**Port Botany Expansion
Community Consultative Committee**

Date: 15 April, 2008

Meeting number: 12

Traffic Management Plan

Compound layout

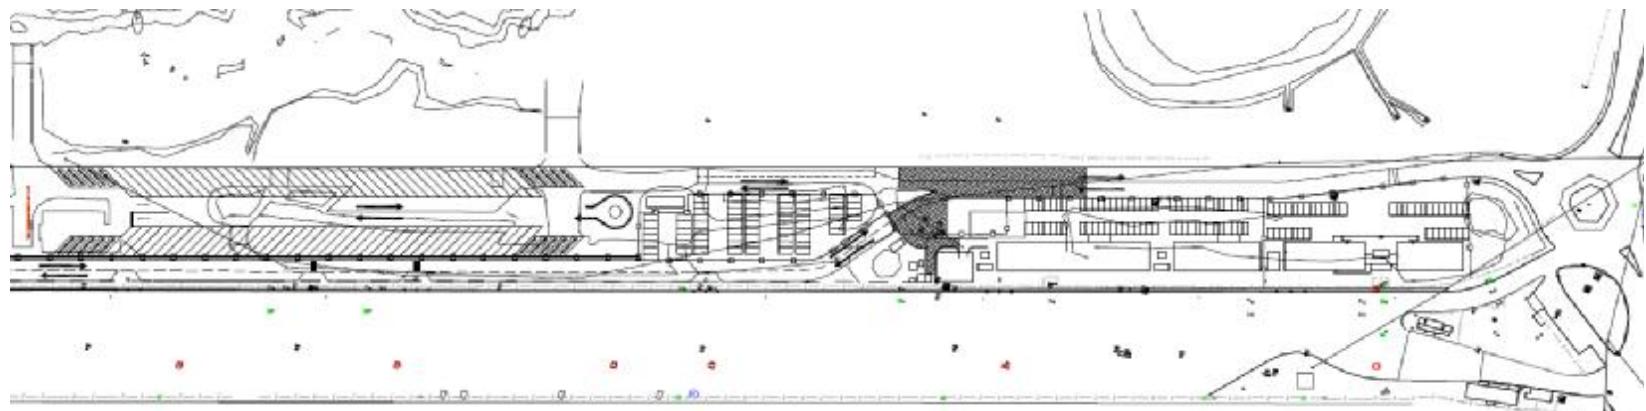
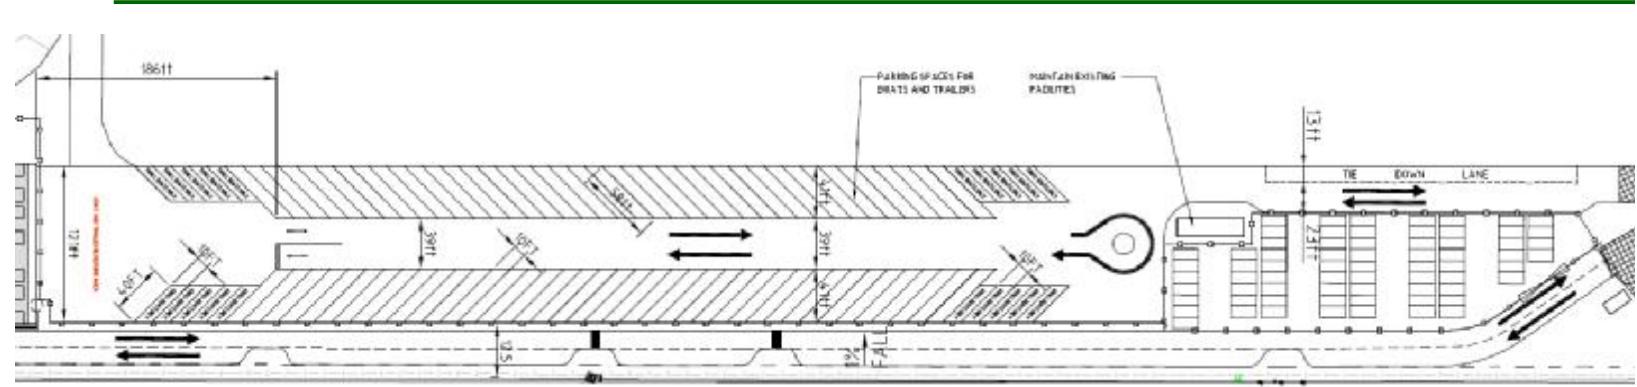
4.1.0	JB suggested that what was not clear from the TMP was the impact of proposed new access roads, roundabouts, access/egress slip lanes and construction activities along Foreshore Rd (eg new boatramp and construction site offices etc) together with the existing Orica barricades, will have on parking along Foreshore Rd generally during the construction period and also post construction. It is foreseeable that much of the road will need to be designated "No parking" and consequently what will be the fate of the trucks/ trailers that regularly park along the road.	BHJDN to respond to impacts of construction on parking along Foreshore Drive. BHJDN to respond to the impact on public parking from workers involved in construction around the boat ramp.

<p>BE asked how many construction workers were expected on site at any one time and how will they access the site.</p> <p>VN replied that 400 workers were expected on site and 178 parking spaces would be provided. Access to the site would be via Penrhyn Rd.</p> <p>JB asked where workers involved in construction of the new boat ramp and on the main project would park and what impact this would have on public parking in the existing boat ramp area and also along Foreshore Rd.</p> <p>BE expressed concern at the impact of an extra 400 cars on the roads in peak periods and the impact on local roads.</p>

4.1.2	<p>NM questioned the mention in the TMP of 100 car parking spaces being maintained.</p> <p>VN replied these would be for the public with separate parking for BH workers.</p> <p>NM noted the irony of talking about 4 trucks an hour, compared with volume of traffic during the operation phase.</p>			
5	Upcoming Consultation

Concept TCP – Intersection Construction

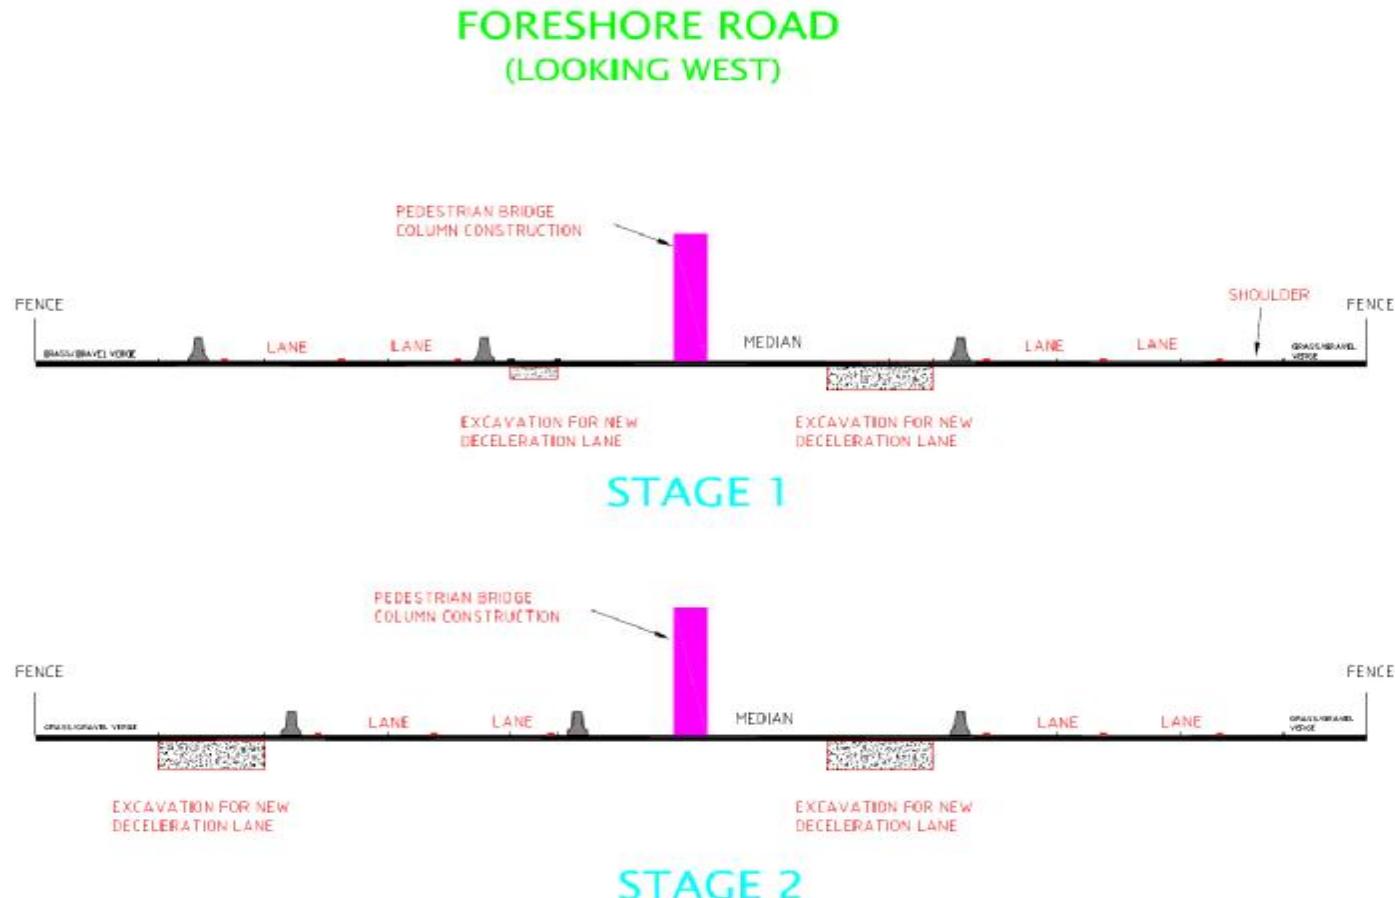
An outline emergency response protocols and protocols for working with RTA Traffic Controllers.			
4.2	<p>JB questioned how the figures in peak periods were arrived at in the modeling. He expressed doubt about the estimations of time for traffic passing through the intersection at Botany Rd and Foreshore Dr as there were often major delays for traffic before they reached the intersection (up to 20 minutes).</p> <p>KV replied that the intersection was monitored and counts taken for 4 hours in the morning and 4 hours in the afternoon. The peak 1 hour in the am and pm is then selected and those volumes modeled accordingly. This is a universally accepted method of modeling used by RTA and was used in EIS modeling.</p> <p>VN noted that the modeling relates to intersection capacity. This may be affected at particular times by one incident e.g. a truck queuing across the intersection. We have to put in place protocols to ensure the existing situation is not made worse. We can stage deliveries so that trucks are not arriving during delays.</p> <p>JB accepted that trucks from the construction were unlikely to have a major impact, but the existing arrangements were not working well.</p>
